Docket No. 70-1100
License No. SNM-1067
TAC No. L30875

Subject: Amendment Request To Downgrade License No. SNM-1067

COMBUSTION ENGINEERING, INC.
WINDSOR SPECIAL NUCLEAR MATERIAL LICENSE
AMENDMENT REQUEST TO DOWNGRADE LICENSE NO. SNM-1067
EXPLANATION OF CHANGES

COMBUSTION ENGINEERING, INC.
WINDSOR SPECIAL NUCLEAR MATERIALS LICENSE
AMENDMENT REQUEST TO DOWNGRADE LICENSE NO. SNM-1067
LIST OF AFFECTED PAGES

Figure 8-1

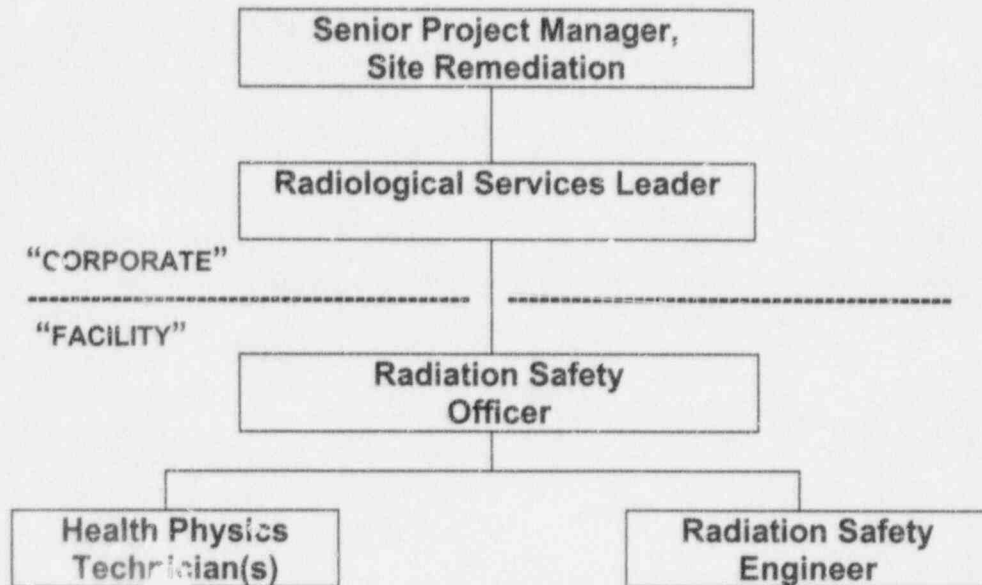
The personnel organization would be changed to reflect the proposed reduced scope of SNM activities to only activities related to waste material. A statement is added to Section 2.1.2 that CE management is responsible for safe operation under the license. The Radiation Safety Officer would be given responsibility for the related radiological activities. The RSO's immediate superior, formerly the Supervisor, Chemistry Services, would be deleted from Section 2.2.1 of Part I of the Application and replaced in Part II by the Radiological Services Leader, who reports to the Senior Project Manager, Site Remediation. A revised Figure 8-1 would show the changes to the personnel organization.
